DESIGN REVIEW TECHNICAL ADVISORY COMMITTEE MEETING

April 13, 2015

1. **1409 3rd Street SE**
NewBo Plaza – Craig McCormick (Applicant)
 - Preliminary Site Development Plan & Façade Review

DESIGN REVIEW TECHNICAL ADVISORY COMMITTEE STAFF REPORT

Flood Proofing Plan

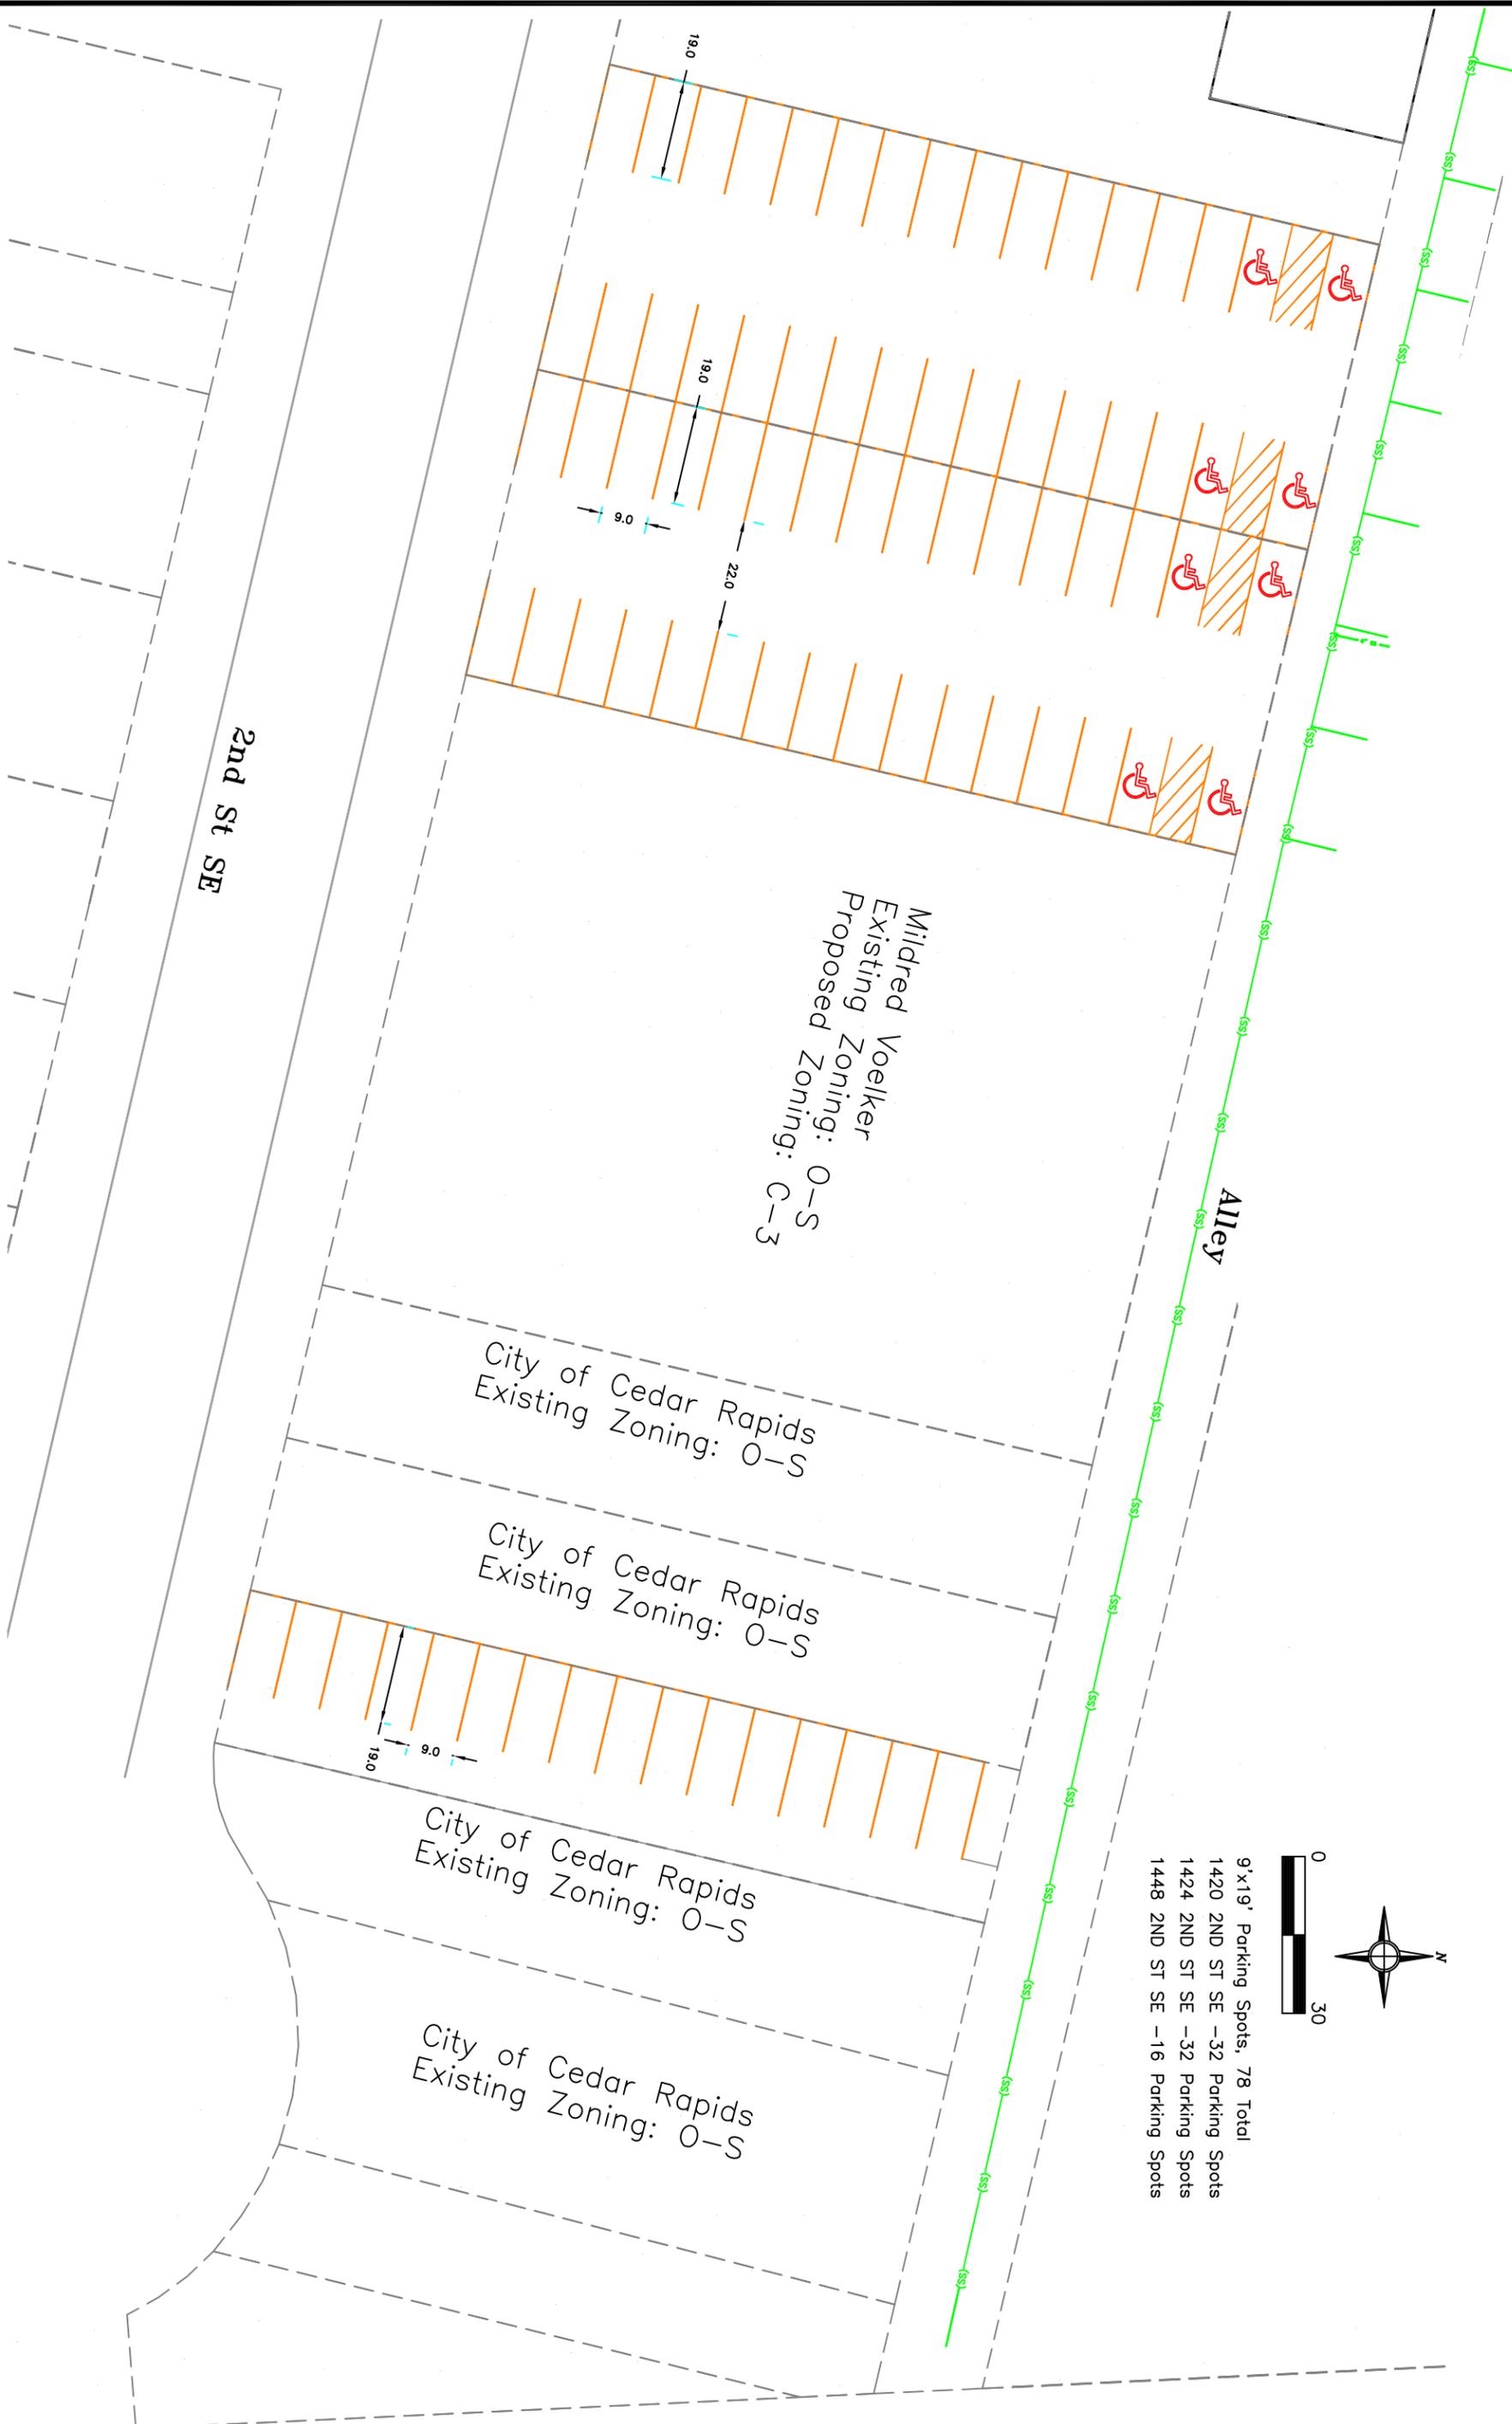
1. Use consistent building materials, take existing buildings in the district into consideration

2. Use clear, consistent windows
3. Install a wrought iron fence similar to the one used in the renderings

1. Paint the white portion of the building to match the rest of the project (consistency)
2. Clean up the billboard and paint the posts to match the building

1. Replace the garage doors and paint them to match the building
2. Make the roofline of the new construction consistent (the applicant made a commitment to this recommendation)
